Access Compliance Report

Public Rights-of-Way

(Curb Ramps)

Intersection ID: 15160	Main Street: GRIFFITH_ST	Cross Street: S_TRYON_ST	Location: SE
ADA ID: 427ADB107ED7	Ramp Type: Perp	Initial Pass/Fail: Fail	Overall Compliance: No
Severity Score: 12.5			
Codes/Mitigation Info/Possible Solution		Field Measurements/Component Compliance

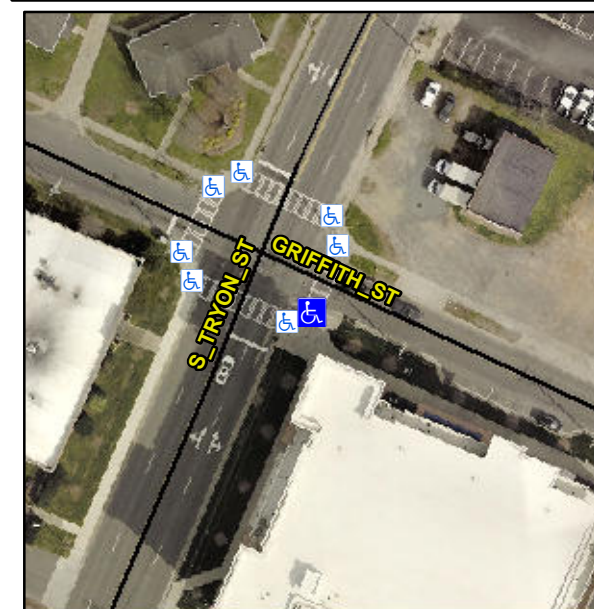
Not Found, R304.2.2

Compliance	Description	Data	Compliance	Description	Data
N/A	Ramp Length (in)	103.0	No	Ramp Slope (%)	8.5
Yes	Ramp Width (in)	48.0	Yes	Ramp XSlope (%)	1.7
N/A	Flare Type LT	N/A	N/A	Flare Type RT	N/A
N/A	Flare Slope LT (%)	N/A	N/A	Flare Slope RT (%)	N/A
N/A	Flare Traversable LT?	N/A	N/A	Flare Traversable RT?	N/A
N/A	Landing Length (in)	N/A	N/A	DWS Provided?	N/A
N/A	Landing Width (in)	N/A	N/A	DWS Contrast?	N/A
N/A	Landing Slope (%)	N/A	N/A	DWS Length (in)	N/A
N/A	Landing X Slope (%)	N/A	N/A	DWS Full Width?	N/A
N/A	Landing Curb? (Y/N)	N/A	N/A	DWS Offset (in)	N/A
N/A	Shared Landing?	N/A			
N/A	Gutter Ponding?	N/A	N/A	Gutter Slope (%)	N/A
N/A	Gutter Lip Ht (in)	N/A	N/A	Gutter X Slope (%)	N/A
N/A	Painted X Walk1?	Yes	N/A	Painted X Walk2?	N/A
	X Walk 1 Direction	To NE		X Walk 2 Direction	N/A
N/A	X Walk 1 Width (in)	102.0	N/A	X Walk 2 Width (in)	N/A
	X Walk 1 Slope (%)	4.5		X Walk 2 Slope (%)	N/A
	X Walk 1 X Slope (%)	1.9		X Walk 2 X Slope (%)	N/A

Remove & Replace Entire Ramp.
